**Miscellaneous:** Trucks with central gear RBP735, RBP835, RP735 or RP835.

## New versions of central gears are introduced as spare parts

317275

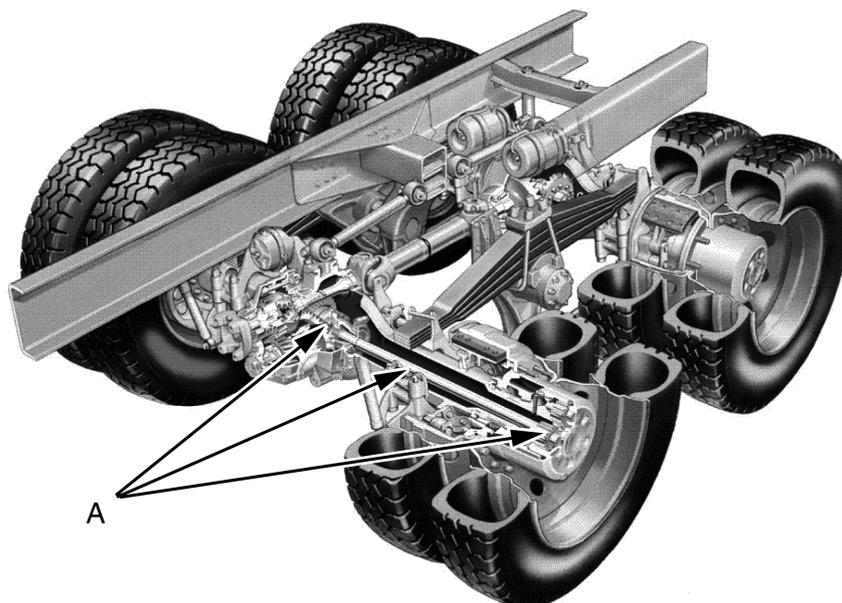
Trucks with hub reduction gears have displayed problems with reducing the pulling power when driving in tough operating conditions. This may lead to insufficient comfort, poor performance and in worst case serious damage to the half shafts **A** and other components.

A number of improvements to the powertrain, primarily at the half shafts, have been introduced in stages to reduce powertrain judder. Amongst other things, the increased diameter of the half shafts has had a major effect. These actions have led to a much improved service life for the central gears.

Due to the fact that the diameter of the half shafts has been increased, other parts, such as the sun wheel in the hub reduction gear, washers, differential pinion, differential housing and oil pipes, must be modified to fit.
